## REVISION

| MATERIAL   |         | CHECKED BY         |         | TITLE<br>4.1/9.5 DIN50 CABLE PS 141FJ                                            |
| FINISH     |         | SCALE              | UNIT    | DWG NO. CN03523-7/3                                                              |

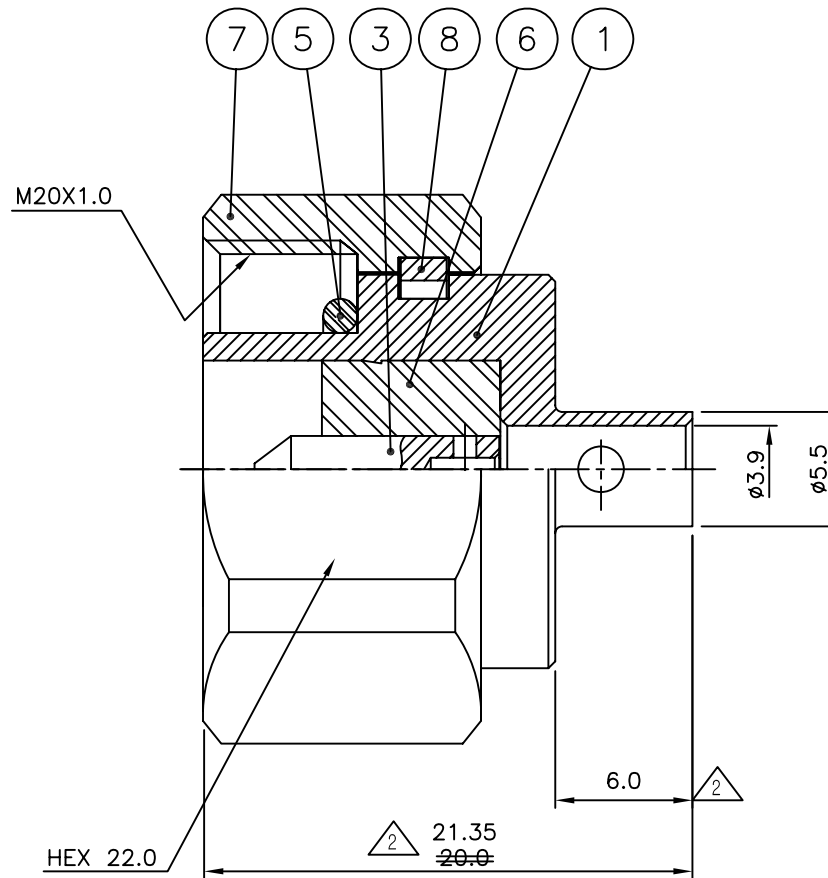
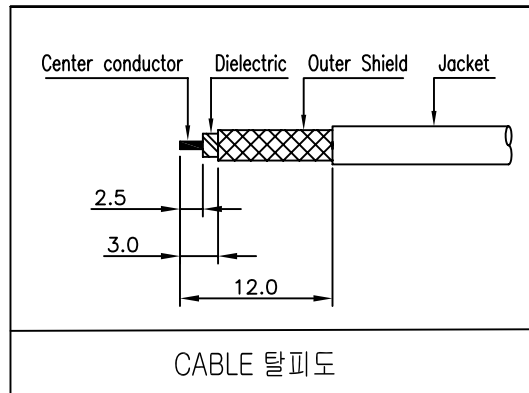
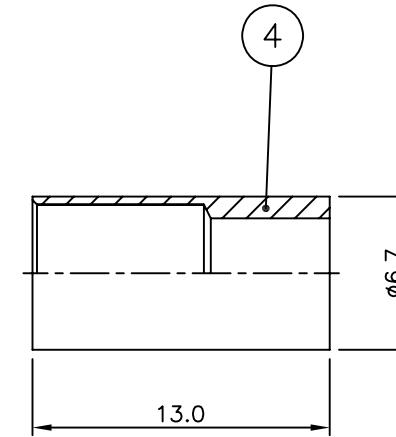
| REV | DESCRIPTION                                              | DRAWN   | APPR    | DATE        |
|-----|----------------------------------------------------------|---------|---------|-------------|
| 1   | CAP 빠짐 현상으로 인한 CAP, BODY 치수 수정 및 CODE 변경                 | H.J.LEE | I.C.KIM | 2016.02.19. |
| 2   | [설번No.201707-0013] 납땜성 향상으로 인한 BODY 변경, 납땜Hole 추가, 패를 변경 | S.Y.EUN | I.C.KIM | 2017.07.21. |

| 8            | SPRING RING     | 1            | PBR                            | Nickel Plate          | DSR00020-5/1                            |
|--------------|-----------------|--------------|--------------------------------|-----------------------|-----------------------------------------|
| 4            | FERRULE         | 1            | MBsBD<br>C3604BD-F             | Nickel Plate          | DFE00205-5/1<br><del>DFE00183-5/1</del> |
| <del>2</del> | <del>BODY</del> | <del>1</del> | <del>MBsBD<br/>C3604BD-F</del> | <del>SUCO Plate</del> | <del>DBD03073-5/2</del>                 |
| 1            | BODY            | 1            | MBsBD<br>C3604BD-F             | SUCO Plate            | DBD04068-5/4<br><del>DBD04068-5/3</del> |
